STATE OF CONNECTICUT
CONNECTICUT SITING COUNCIL

DOCKET NO. 451

**HOMELAND TOWERS, LLC (HOMELAND) and NEW CINGULAR WIRELESS,
PCS LLC (AT&T)
RESPONSES TO ARCESI
PRE-HEARING INTERROGATORIES - SET ONE**

ATTACHMENT 1

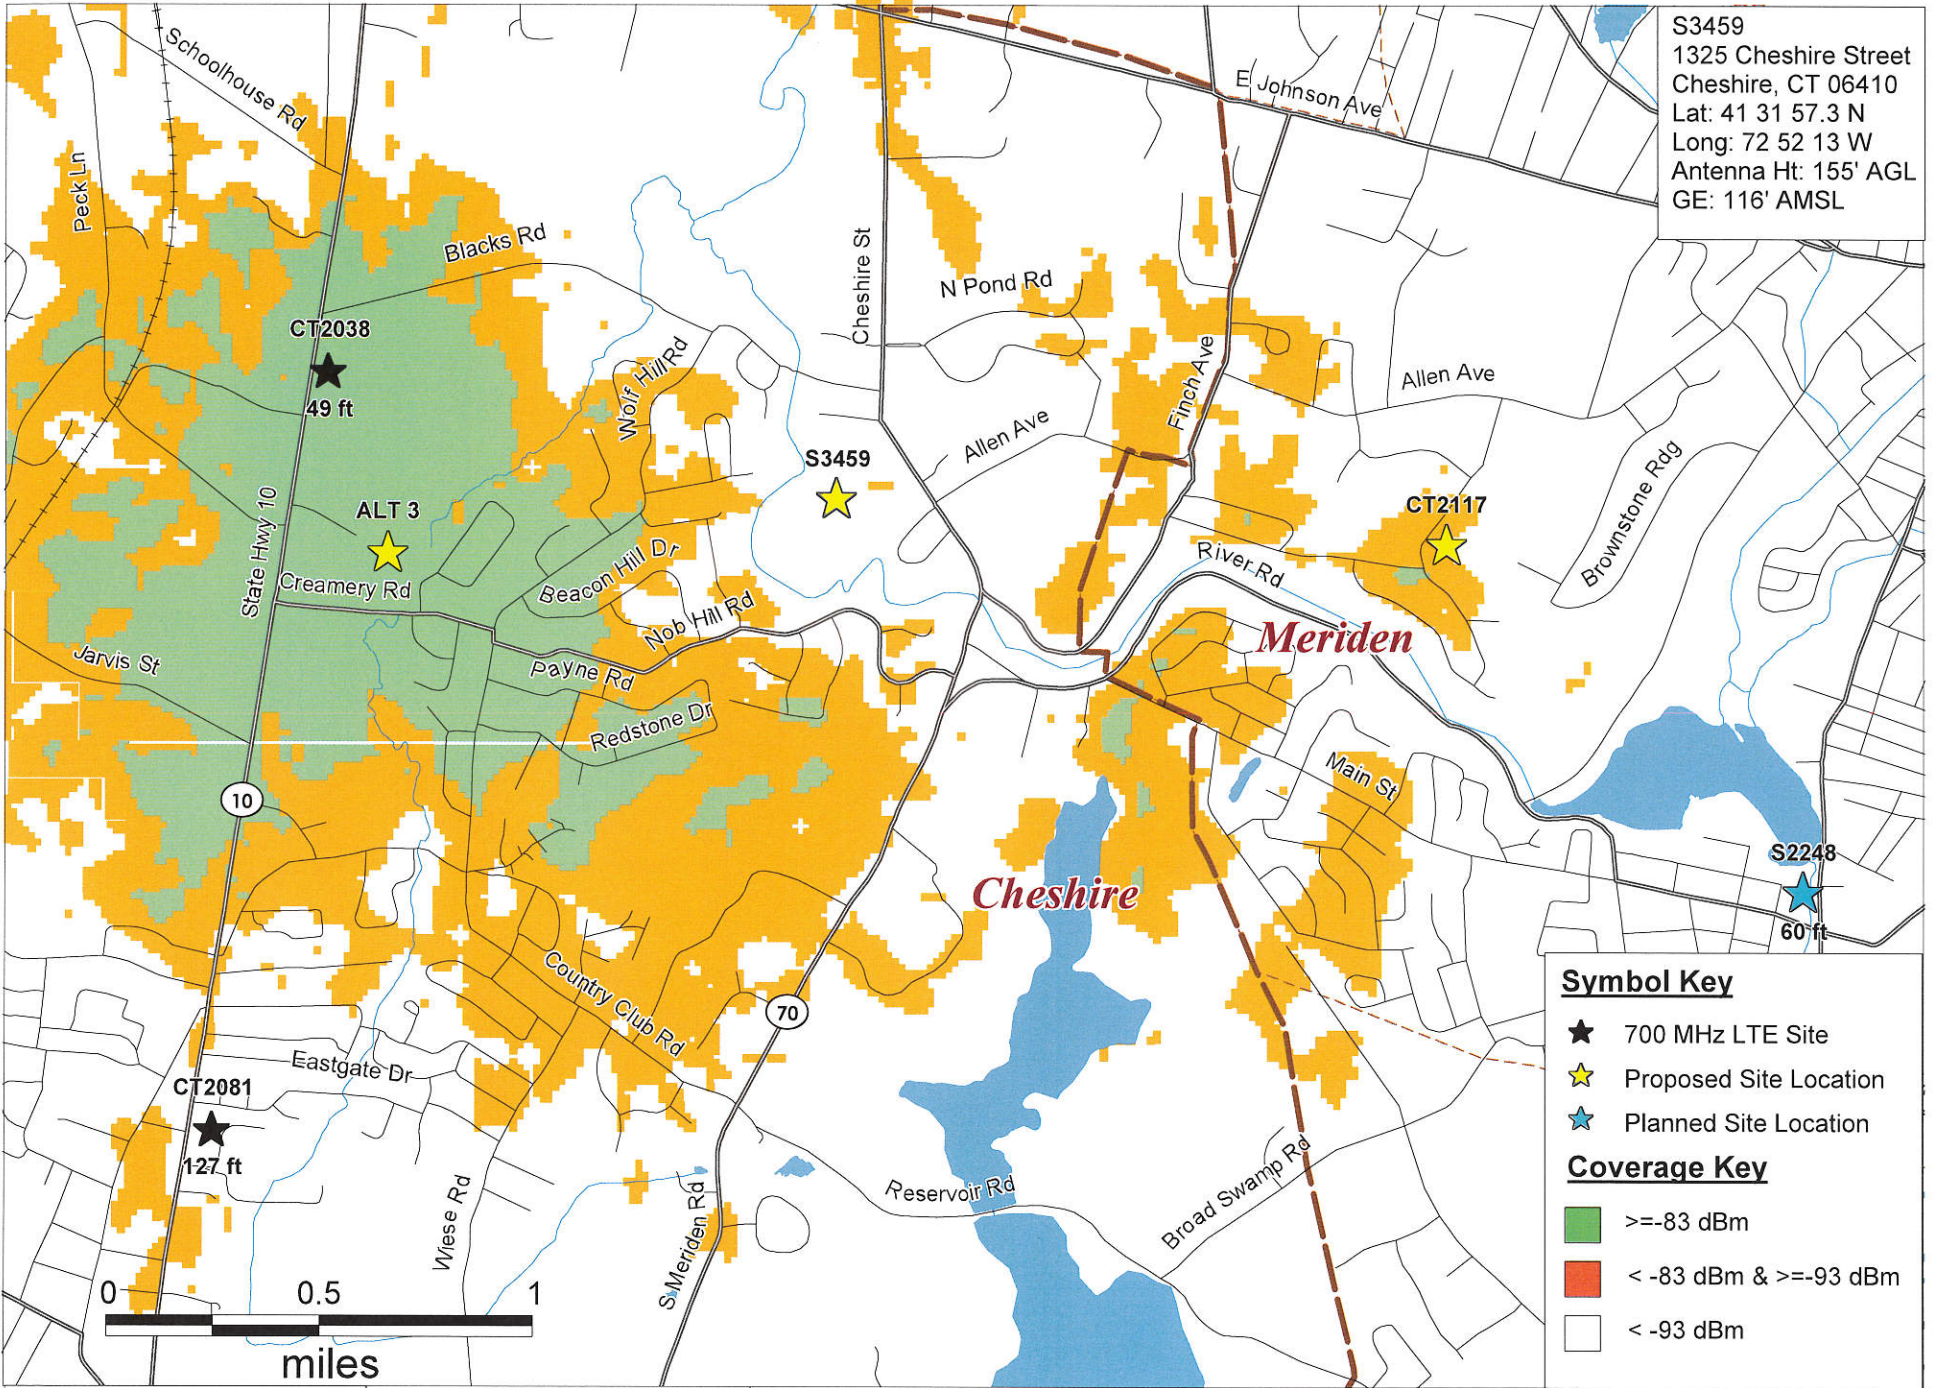
Q7. Will Homeland Towers please provide the site investigation results for Milone and MacBroom at 99 Realty Drive that show the testing at 170'-180.' The proposal states a rooftop tower was considered at 55' but testimony states 180' was also considered and coverage objectives were not met. This site is located in Cheshire's industrial zone, has a higher elevation (140') and the landowner has expressed interest in siting the tower. The site is only 6,000' or 1.13 miles +/- from the proposed site.

A7. *Please see attached coverage map. A site at that location would not adequately provide reliable service to the area of need. Moreover, due to its proximity to an existing AT&T site much of the coverage would be duplicative.*
